THE VILLAGE AT TOTEM LAKE

COVER SHEET

CITY OF KIRKLAND
PLANNING AND BUILDING DEPARTMENT

THE SCOPE OF WORK INCLUDES THE RECONFIGURATION OF SPACE TO CONSTRUCT NEW SALES AREA AND STOCK AREA; CONSTRUCTION OF ONE (1) NEW TOILET ROOM TO PROVIDE FULL ACCESSIBILITY; MODIFICATIONS AND EXTENSIONS OF EXISTING MEP SYSTEMS AND INSTALLATION OF NEW MECHANICAL EQUIPMENT, AND MODIFICATIONS TO EXTERIOR STOREFRONT SYSTEM.

DOMESTIC WATER PLAN
1/4" = 1' - 0"

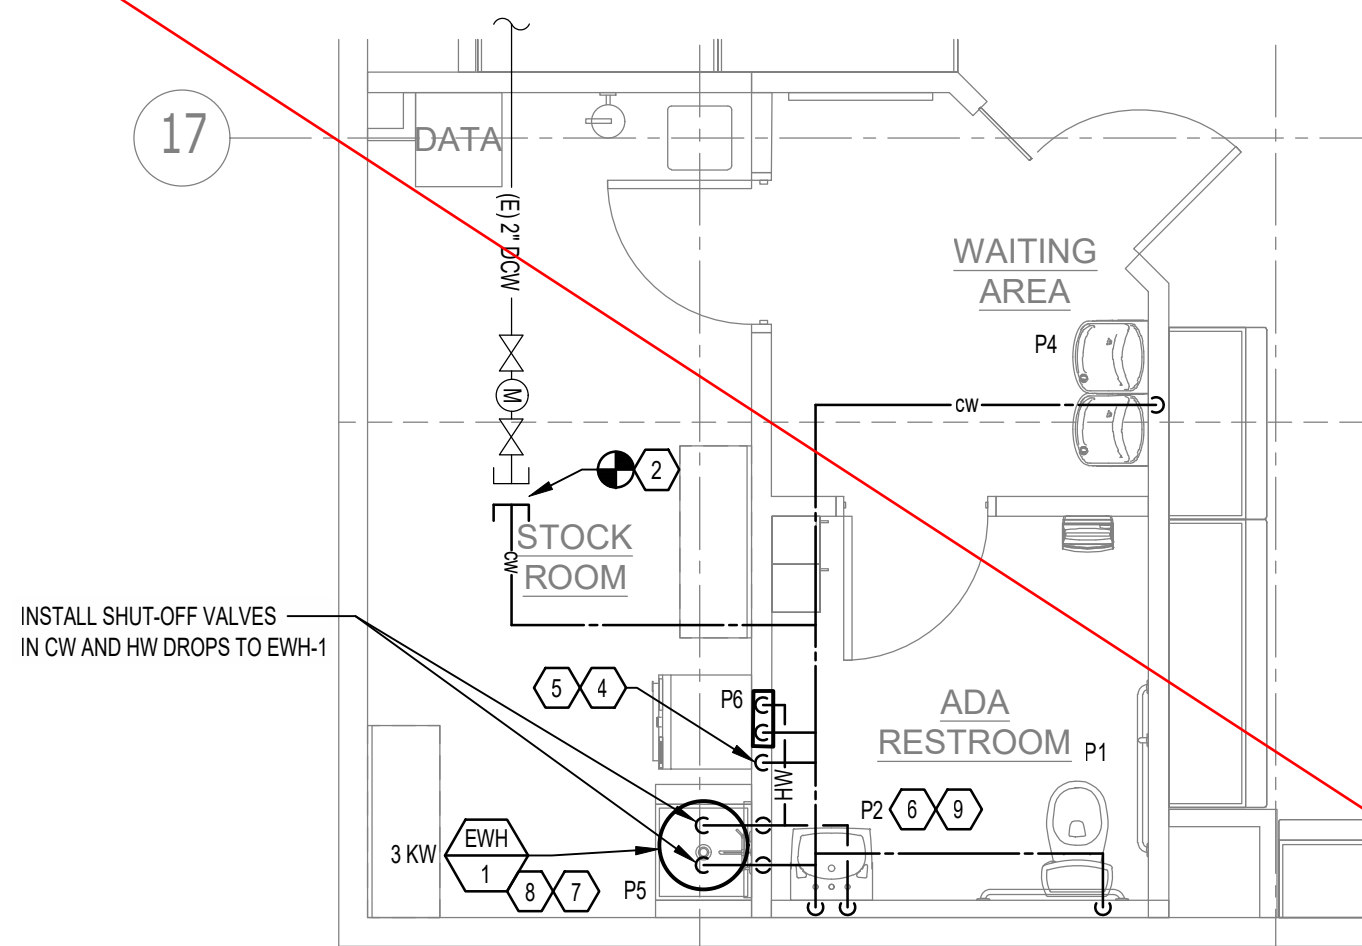
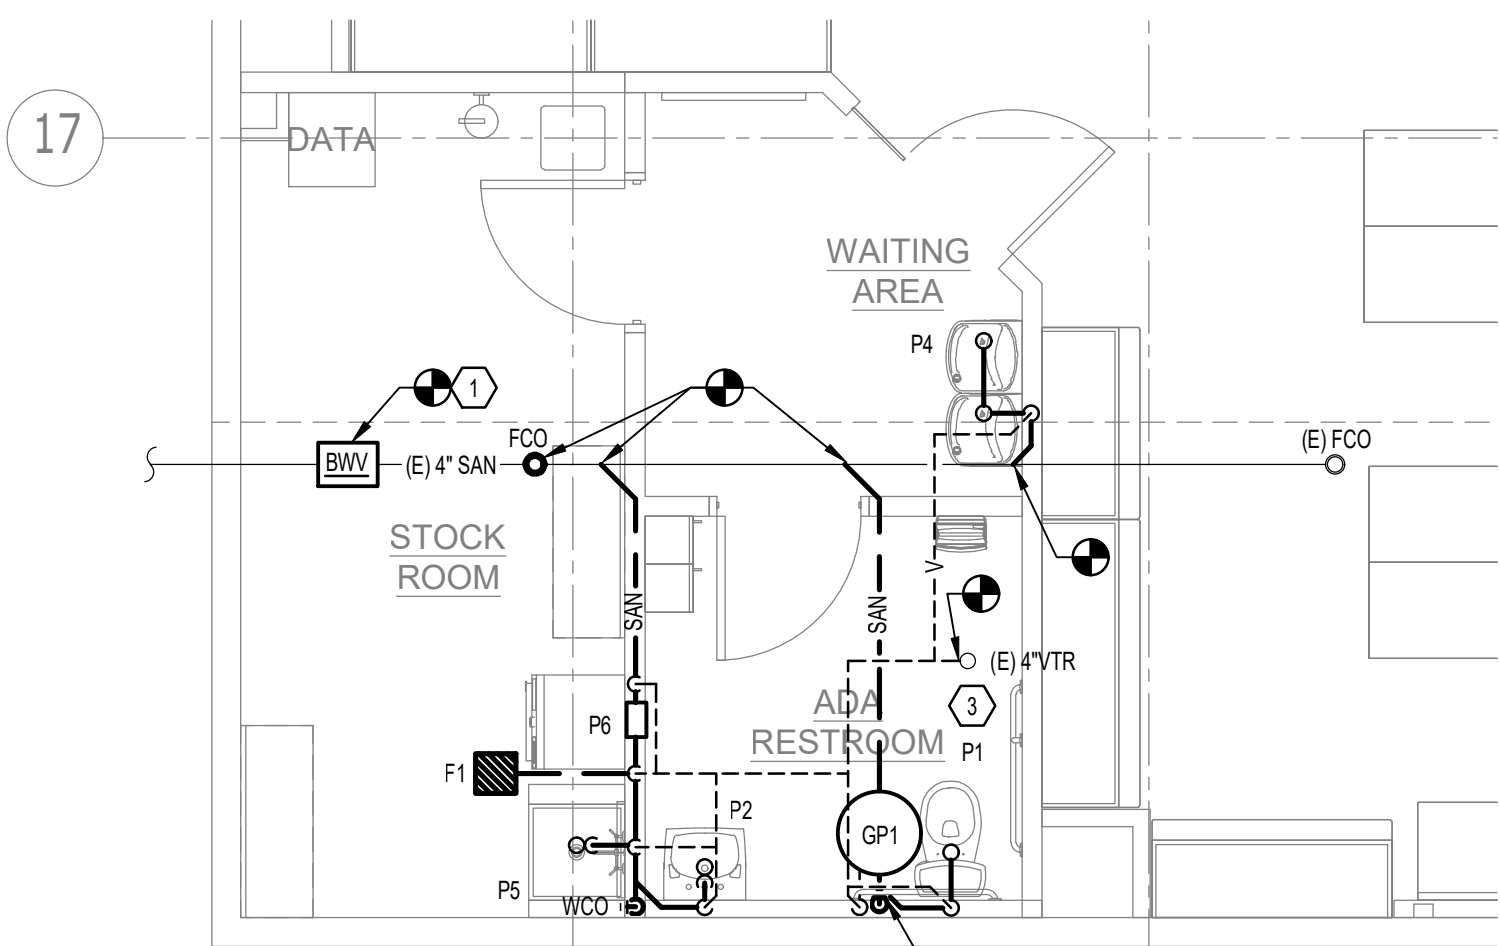
Backwater valve shall be labeled and accessible per the UPC

Insulate new domestic water lines per the UPC and WSEC

Materials for Domestic water lines, Sanitary DWV, and Grease waste lines shall be UPC approved.
